APPLICATION FOR PERMISSION
UNDER SECTION 16 OF
THE TOWN PLANNING ORDINANCE
(CAP.131)

For Official Use Only 請勿填寫此欄	Application No. 申請編號	A146-LFS/455
	Date Received 收到日期	26 JAN 2023

(a) Proposed use(s)/development 擬議用途/發展	Proposed Temporary Warehouse for Storage of Building Materials for a Period of 3 Years (Please illustrate the details of the proposal on a layout plan) (請用平面圖說明擬議詳情)

**Proposed Temporary Warehouse for Storage of Building Materials
for a Period of 3 Years at Lots 2207 RP (Part), 2213 S.A RP, 2213 S.B
& 2214 RP in D.D. 129, Lau Fau Shan, Yuen Long, N.T.**

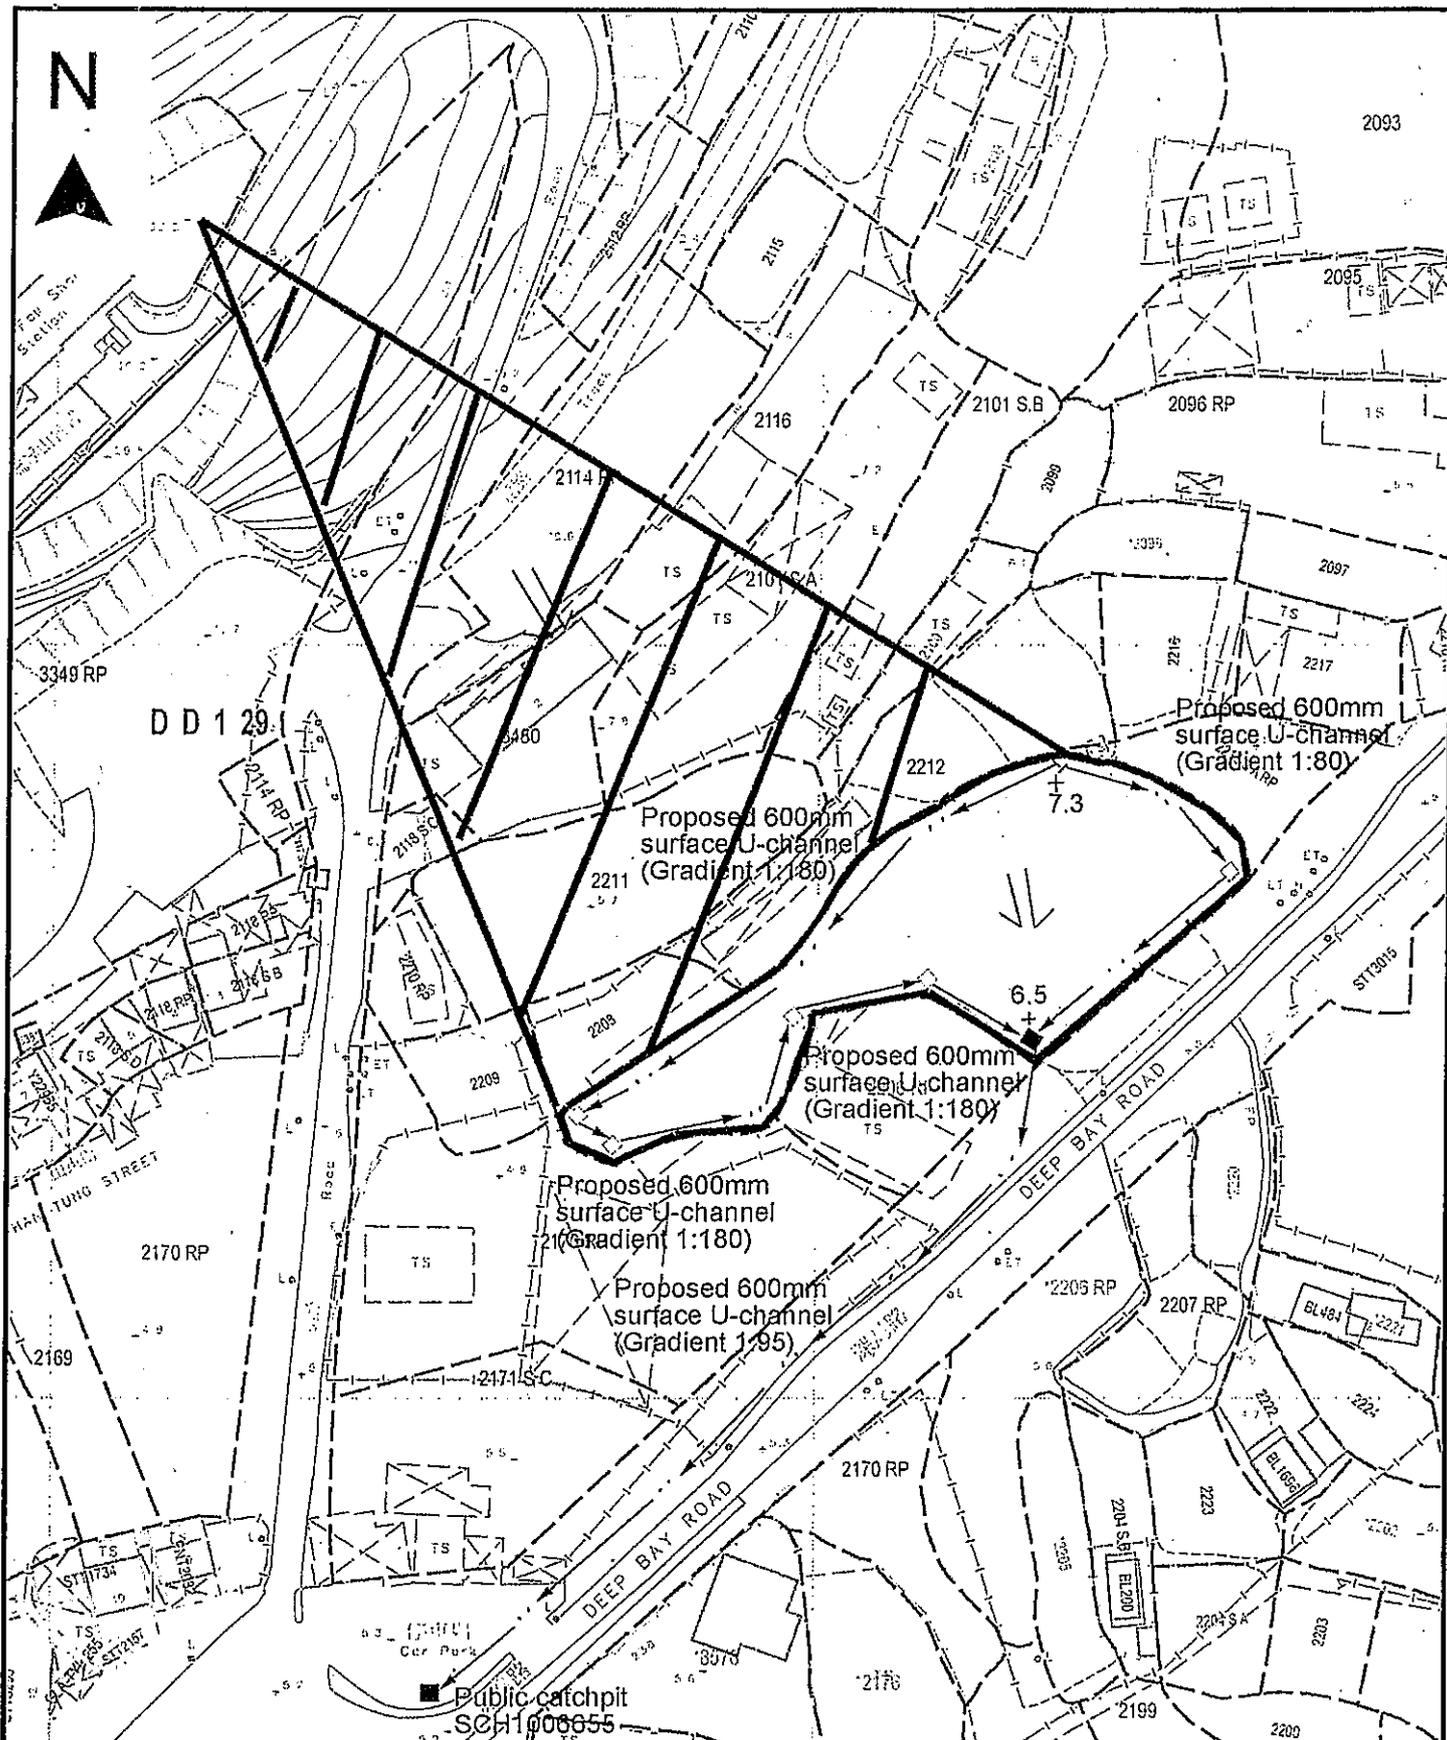
- (f) to note the comments of the Chief Engineer/Mainland North, Drainage Services Department (CE/MN, DSD) on the submitted drainage proposal that:
 - (i) the existing public drainage system, to which the applicant proposed to discharge the stormwater from the Site is not a proper discharge point. The applicant should consider another discharge point and indicate clearly the full alignment of the discharge path from the Site;

- (ii) the cover levels and invert levels of the proposed U-channels, catchpits/sand traps

- should be shown on the discharge plan;
- (iii) cross sections showing the existing and proposed ground levels of the Site with respect to the adjacent areas should be given;

- (iv) standard details should be provided to indicate the sectional details of the proposed U-channels and the catchpits/sand traps;
 - (v) where walls or hoarding are erected along the site boundary, adequate opening should be provided to intercept the existing overland flow passing through the Site;
